Assessment Officer Report

7 Goal Post Road, Mount
Buller
PA2302397

Officer Assessment Report
Development Approvals & Design

Key information	Details		
Application No:	PA2302397		
Received:	31 July 2023		
Statutory Days:	88		
Applicant:	[REDACTED]		
Planning Scheme:	Alpine Resorts		
Land Address:	7 Goal Post Road, Mount Buller		
Proposal:	Buildings and works for the construction of five dwellings, the removal of native vegetation and the reduction of car parking spaces		
Development Value:	\$3.5m		
Why is the Minister responsible?	In accordance with the schedule to Clause 72.01 of the Planning Scheme, the Minister for Planning is the Responsible Authority for administering and enforcing the Alpine Resorts Planning Scheme (the Scheme).		
Why is a permit required?	Clause	Control	Trigger
Zone:	Clause 37.02-4	Comprehensive Development Zone Schedule 1 (CDZ1)	<i>Construct a building or construct or carry out works</i>
Overlays:	Clause 44.06-2	Bushfire Management Overlay Schedule 1 (BMO1)	<i>Construct a building or construct or carry out works for buildings associated with accommodation use</i>

Figure 5 – South elevation – proposed development (Source: Application)

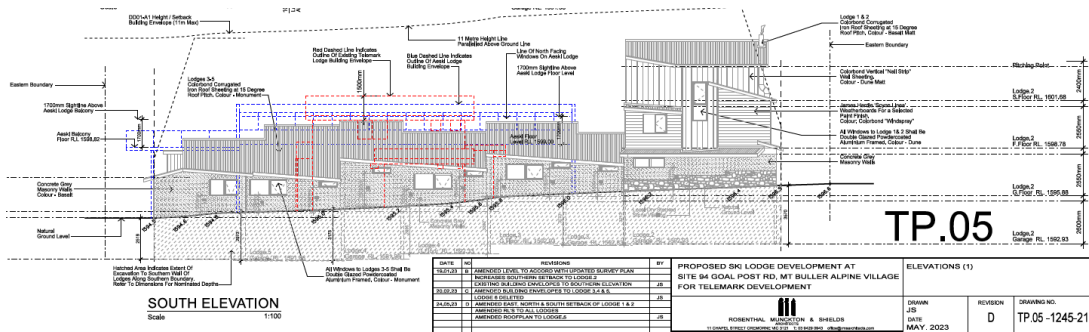
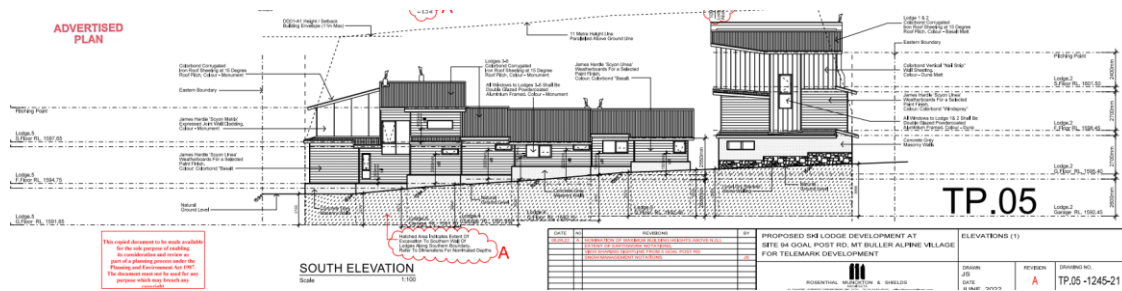
59. The DDO1-A1 includes a requirement for the maximum height of any part of a building to not exceed 3 storeys or 11m above natural ground level. The development has generally been designed to follow the contours of the land. While the ground floor level will be excavated into the land, this has been designed purposely to minimise the overall height of the development. The maximum overall height to each lodge will vary, ranging from 10.9m for Lodge 1 (as the maximum for the whole development) and 6.7m for Lodge 3 (as the lowest). The proposed development therefore complies with the maximum height requirement of the DDO1-A1.

60. It should also be noted that the re-designed proposal forming part of this application, was purposely modified from the earlier application for the development of the site as part of PA2201612, by reducing the overall height of the proposed lodges that were directly in the line of sight from the adjoining lodge (Aeski Lodge) to the south at 5 Goal Post Road. Refer to Figures 5 and 6 respectively for the proposed south elevation and the south elevation of the 'withdrawn' application.

61. The proposed plans also demonstrate that proposed Lodges 3-5 will have a maximum overall height that is approximately 1m lower than the height of the existing lodge on site. Furthermore, the plans show that the proposed Lodges 3-5 will also be lower in height than the existing Aeski Lodge to the south. This will enable views from the Aeski Lodge be retained to at least what is considered reasonable, or at least not totally obstructed as a result of the new development.

Figure 7 – West elevation – Lodge 4 and Aeski Lodge to the south showing view lines (Source: Application)

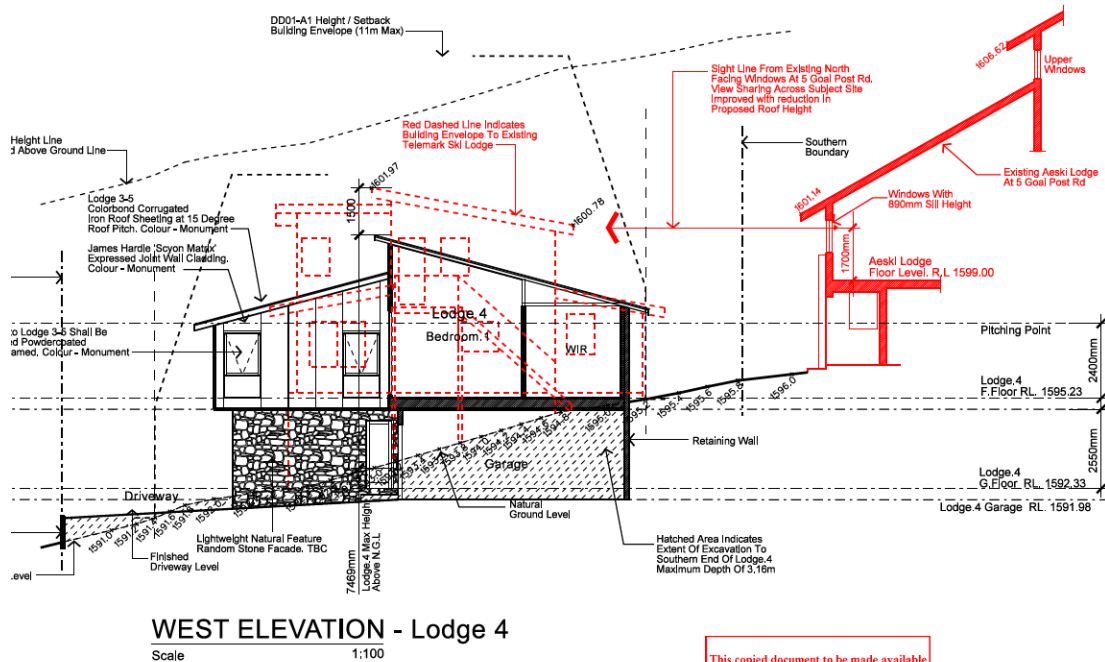
79. A number of the submissions received were from the Aeski Lodge, which is located directly south of the subject site at 5 Goal Post Road. Many of the submitters claim that they will be directly impacted due to losing their views. View corridors for the Aeski Lodge are to the north and the east, where they look out to the ski fields and mountains.

80. The relevant planning controls around views is to ensure view corridors are protected between buildings and provide opportunities for view sharing. It should also be noted many of the submitters who raise this as an issue, raise it in a general sense without stating specifically how they would be impacted. Nonetheless, in response to this issue, it is noted that the Aeski Lodge will sit above the roofline of the proposed development. Furthermore, the proposed development, while it will have a much greater site coverage across the site than the existing lodge (Telemark Ski Club), the part of the proposed development that sits directly in front of the Aeski Lodge (which is predominantly Lodges 3-5) will be approximately 1.5m lower than the existing lodge on the site. The applicant has provided a section of the west elevation for Lodge 4 with the Aeski Lodge which demonstrates that view lines from the Aeski Lodge can still be obtained as the Aeski Lodge sits higher than the proposed development. (Refer to Figure 7).

81. While there may be some impact or loss of views from the lower levels of the Aeski Lodge, on balance, a reasonable level of view lines will be retained, thus achieving the protection of view corridors between buildings, as required by the Scheme.
